**V2500-D5 SERIES PROPULSION SYSTEMS SERVICE BULLETIN**

This document transmits Revision 1 to Service Bulletin EV2500-79-0040

**V2500-ENG-79-0040**

OIL - SCAVENGE OIL TUBES - ENGINE - INTRODUCTION OF REVISED SCAVENGE TUBES AND  
CLIPPING FOR THE NO.4 BEARING

Before alteration  
Figure 1

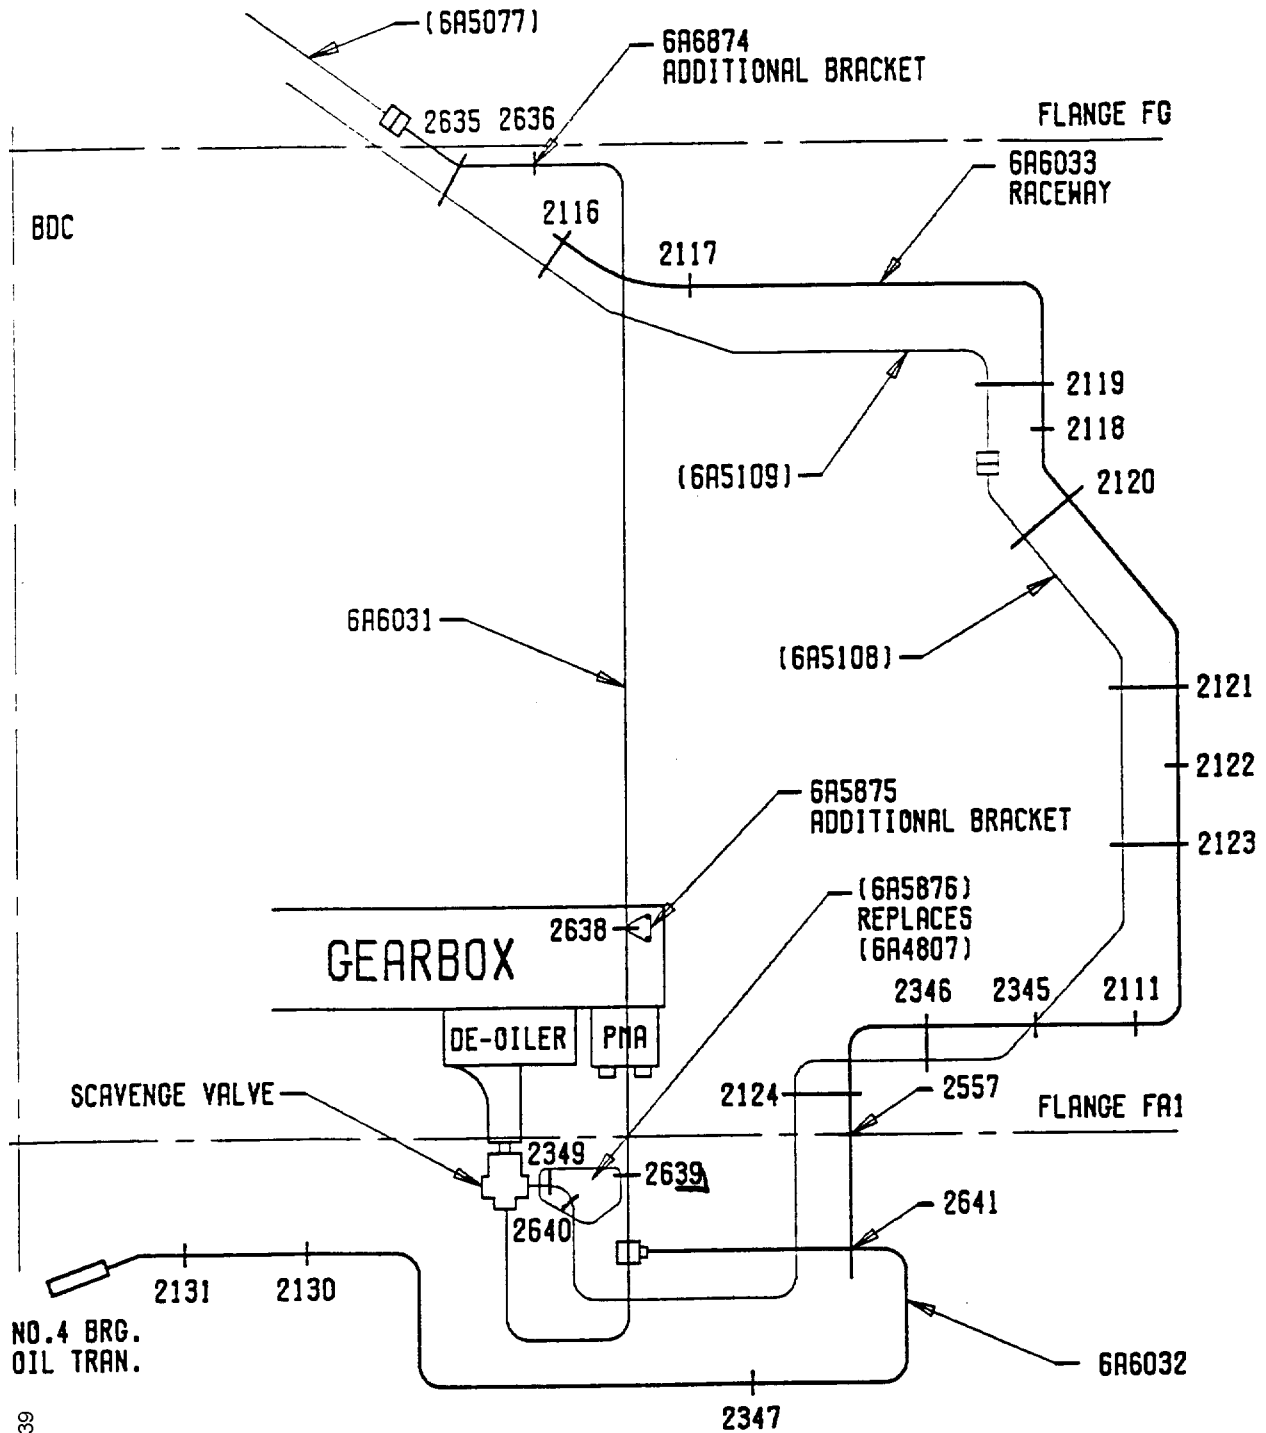
PROCEDURE	RELATED DATA
(1) Remove and discard clip point CP2115	Refer to Figure 1 and Figure 8
(2) Remove and discard tube assemblies 6A5080, 6A5229 and 6A5295	Refer to Figure 1, Figure 7, Figure 9 to Figure 17, Figure 20 and Figure 21
(3) Replace tube assemblies 6A5229 and 6A5295 with raceway 6A6033	Refer to Figure 2

After alteration  
Figure 2

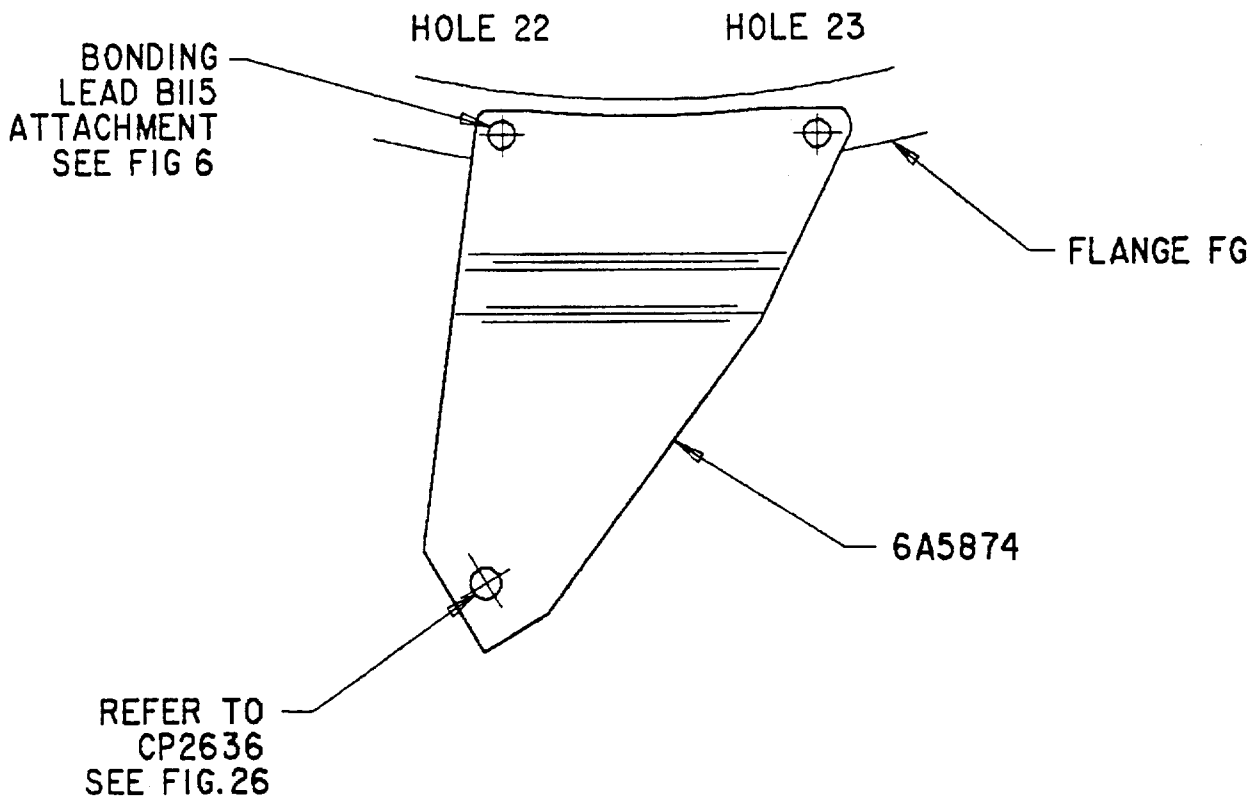
PROCEDURE	RELATED DATA
(a) Attach clip point CP2349 to bracket 6A5876	Refer to Figure 2 and Figure 23
(b) Attach tube 6A5108 to additional clip point CP2640. Then attach CP2640 to bracket 6A5876	Refer to Figure 2 and Figure 28

Refer to Figure 2, Figure 18, Figure 19 and Figure 22

Additional bracket - Refer to CP2636 Figure 26  
Figure 3

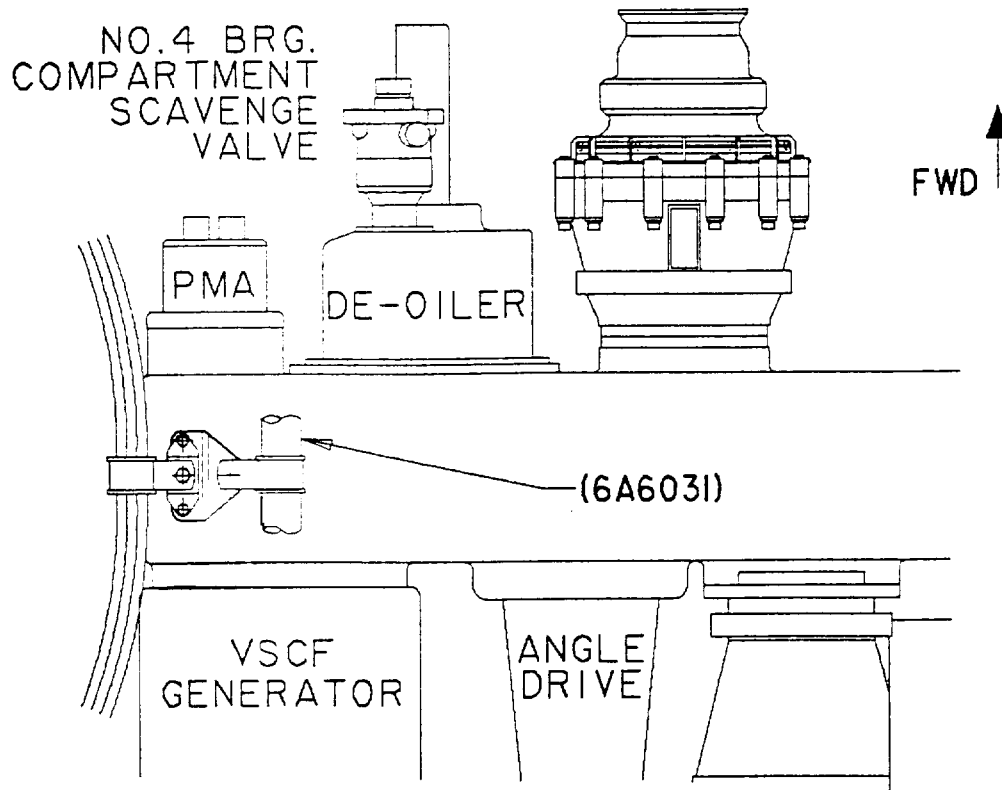
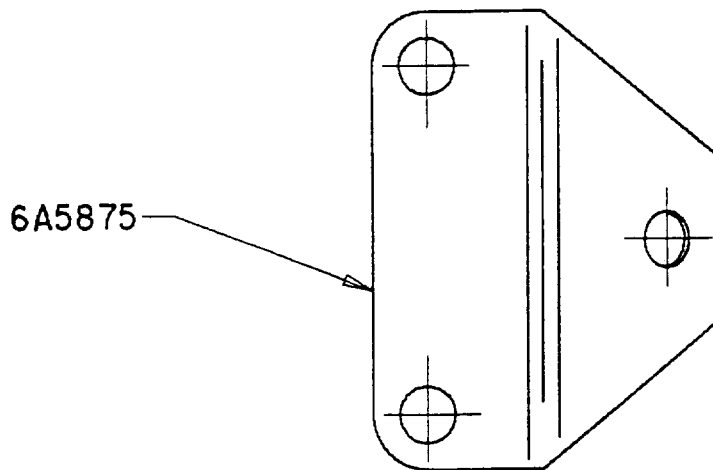
(c) To hold the tube assemblies and harnesses, a raceway assembly is added to replace the initial tube assemblies.

(d) Two brackets are added to hold the additional tube assemblies.

Additional bracket - Refer to CP2638 Figure 27  
Figure 4

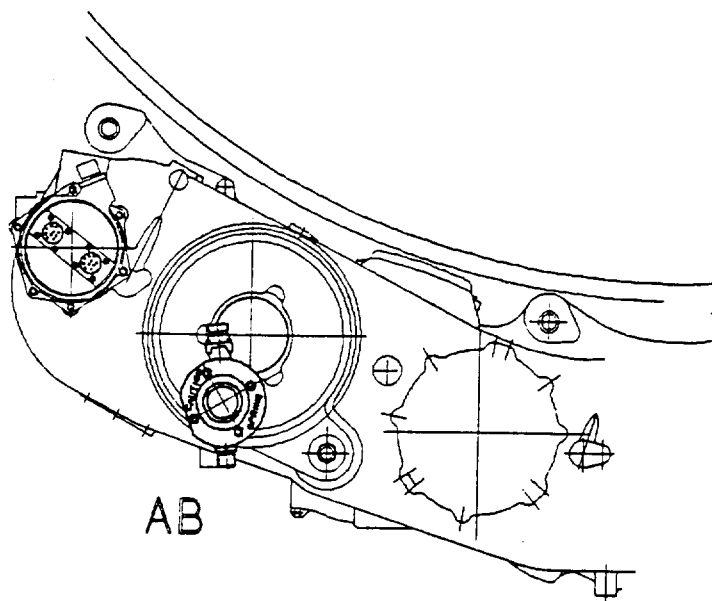
- (b) Attach bracket 6A5875 to gearbox

Refer to Figure 4

Before and after alteration  
Figure 5

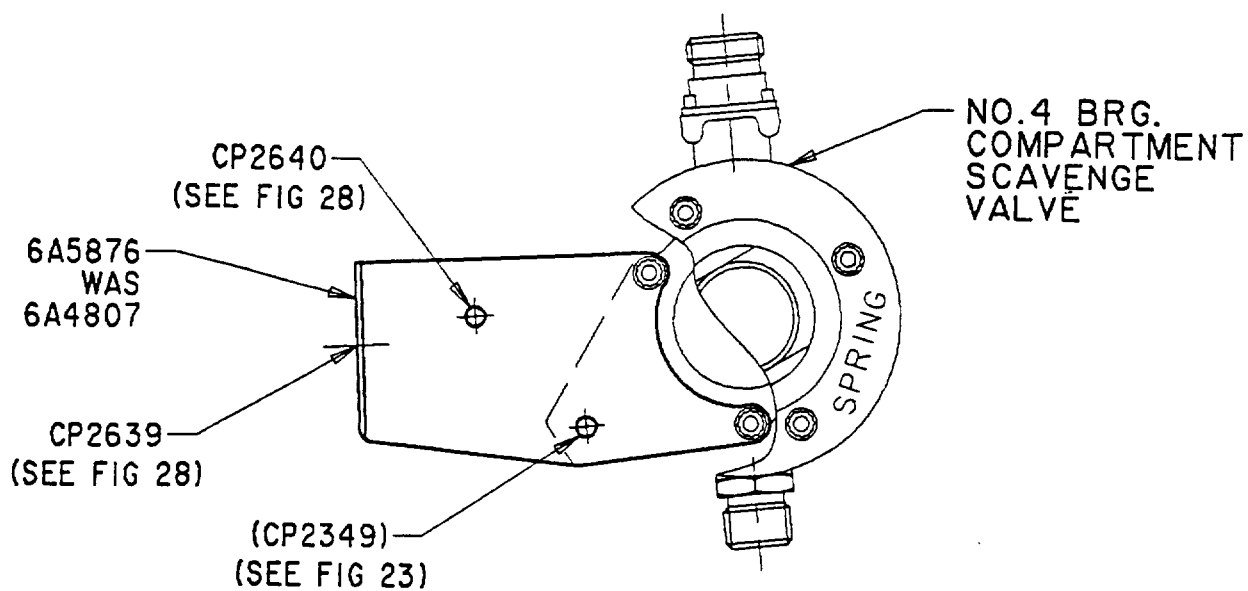
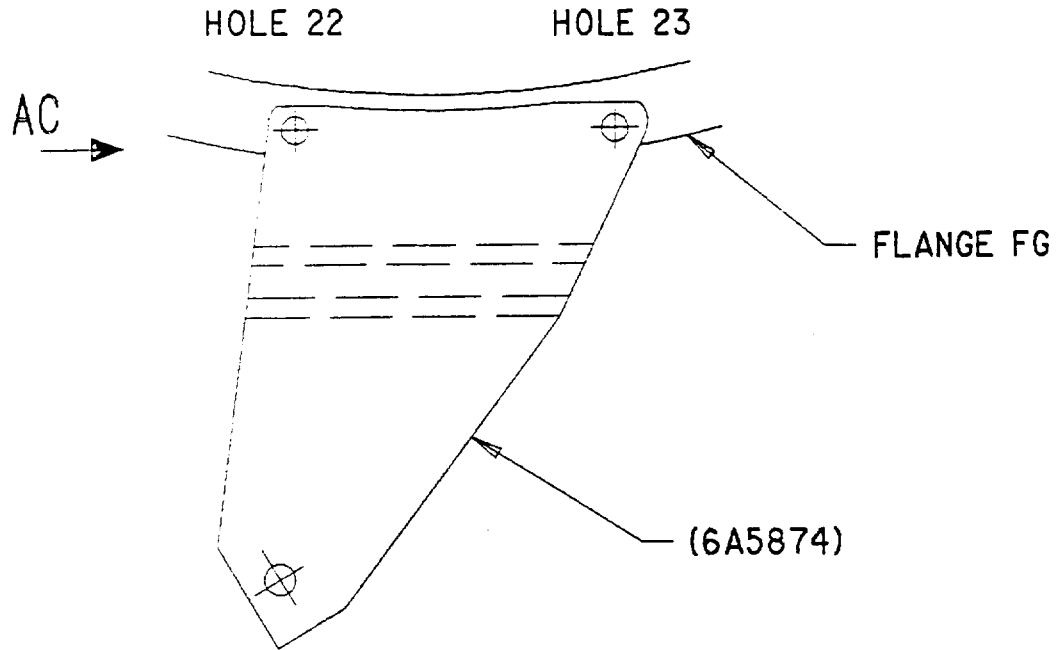
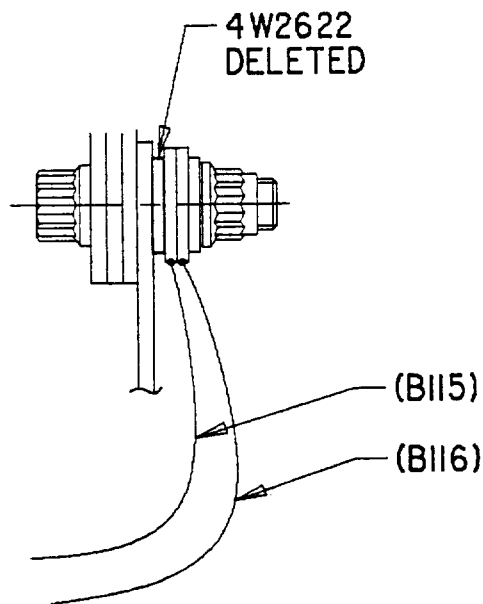
PROCEDURE	RELATED DATA
(4) Replace bracket 6A4807 with bracket 6A5876	Refer to Figure 5

Bonding lead attachment  
Figure 6

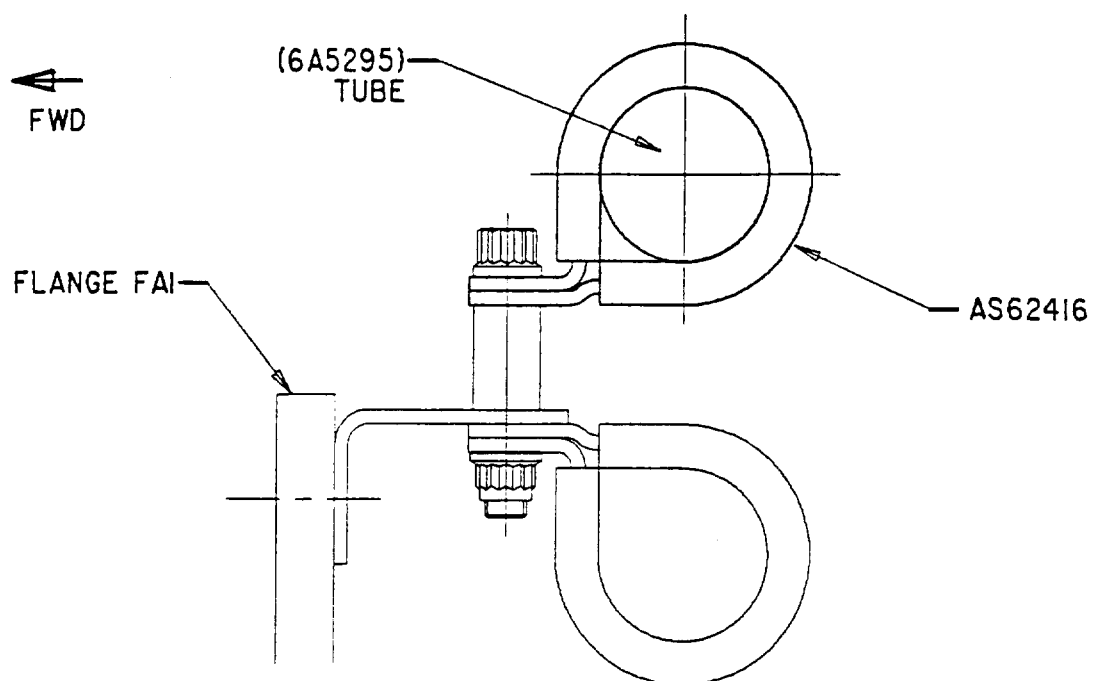
(i) Bonding point B115 has changed.

Clipping Point CP2111 – Before and after alteration  
Figure 7

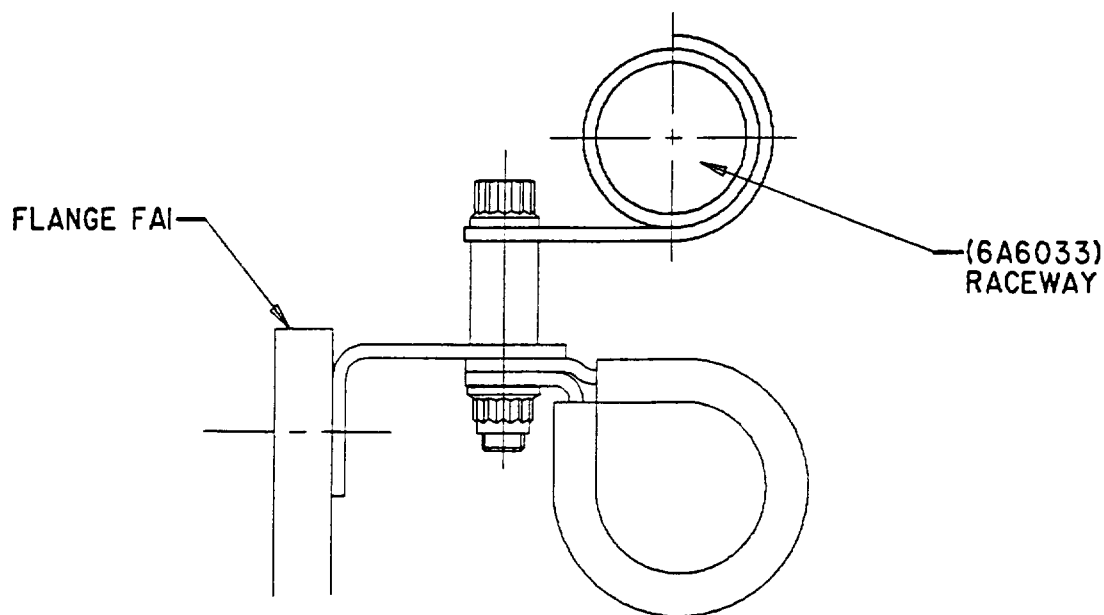
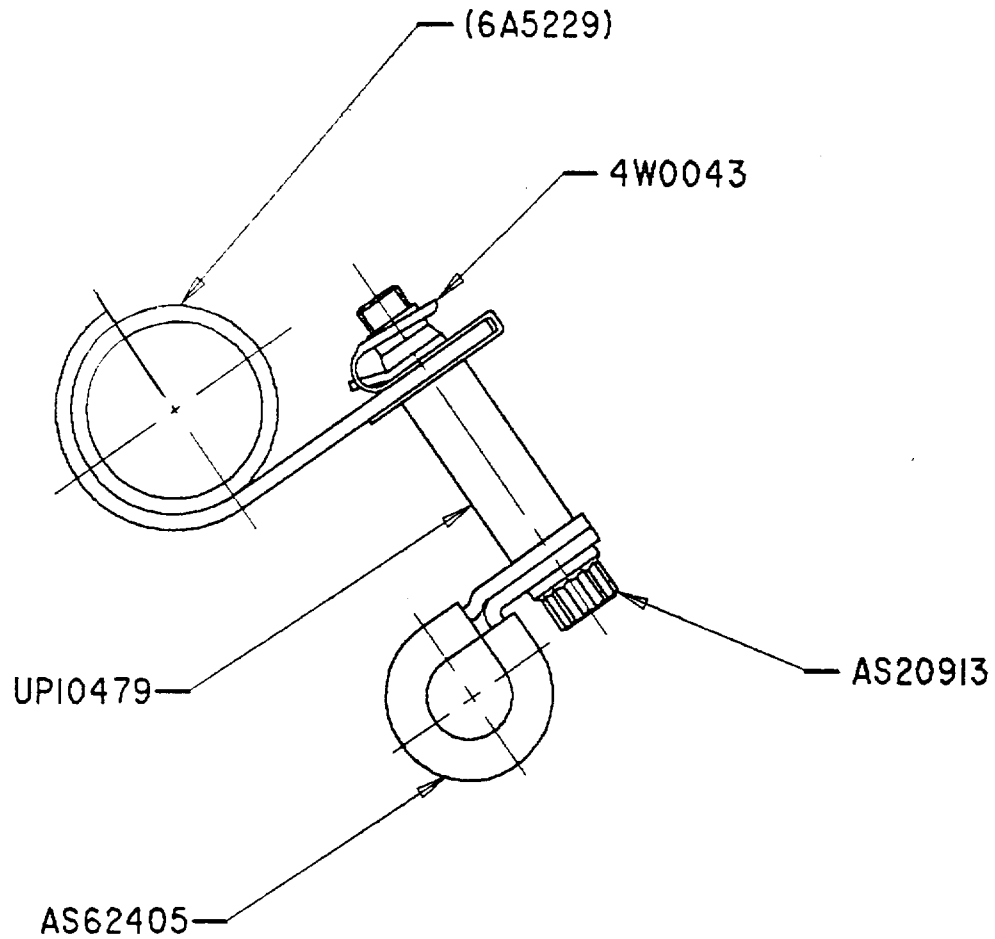
PROCEDURE	RELATED DATA
(a) Attach raceway to clip points CP2116, CP2119, CP2120, CP2121, CP2123 and CP2346	Refer to Figure 9, Figure 12, Figure 13, Figure 14, Figure 16 and Figure 21
(b) Attach raceway to changed clip points CP2111, CP2117, CP2118, CP2122, CP2124, CP2345 and CP2557	Refer to Figure 2, Figure 7, Figure 9 to Figure 17, Figure 20 and Figure 24
(c) Attach raceway to additional clip point CP2641	Refer to Figure 29

Clipping Point 2115 - Deleted  
Figure 8

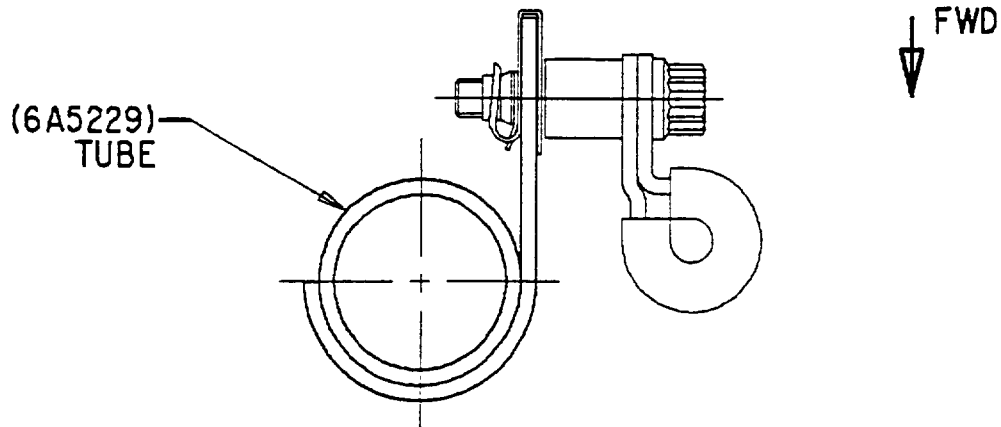
(h) Clip point CP2115 is removed and discarded.

Clipping Point 2130 – Before and after alteration  
Figure 18

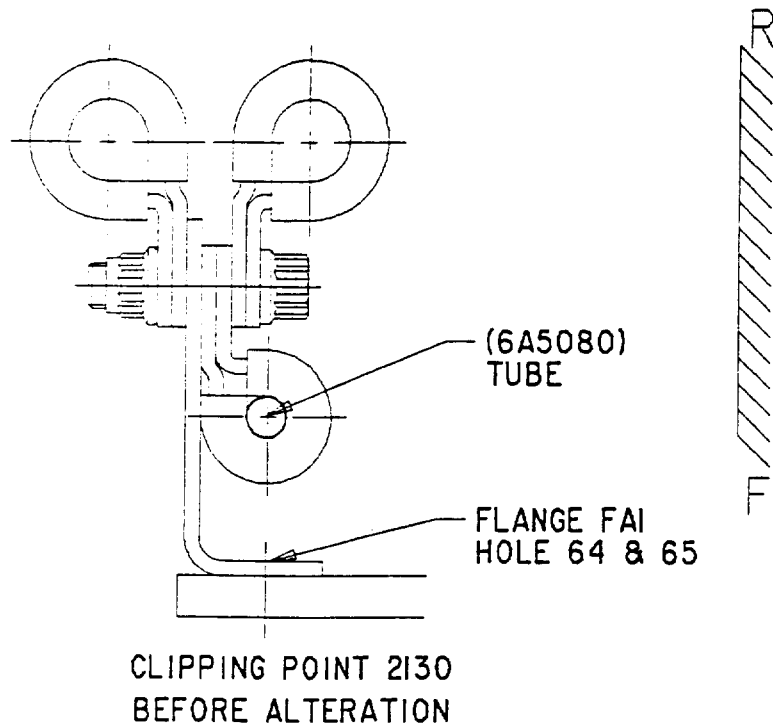
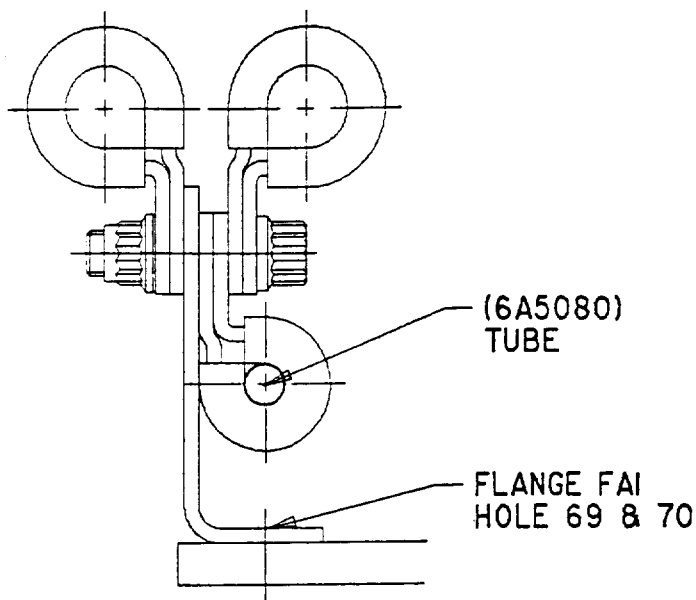
- (a) Attach tube to clip points CP2130, CP2131 and CP2347
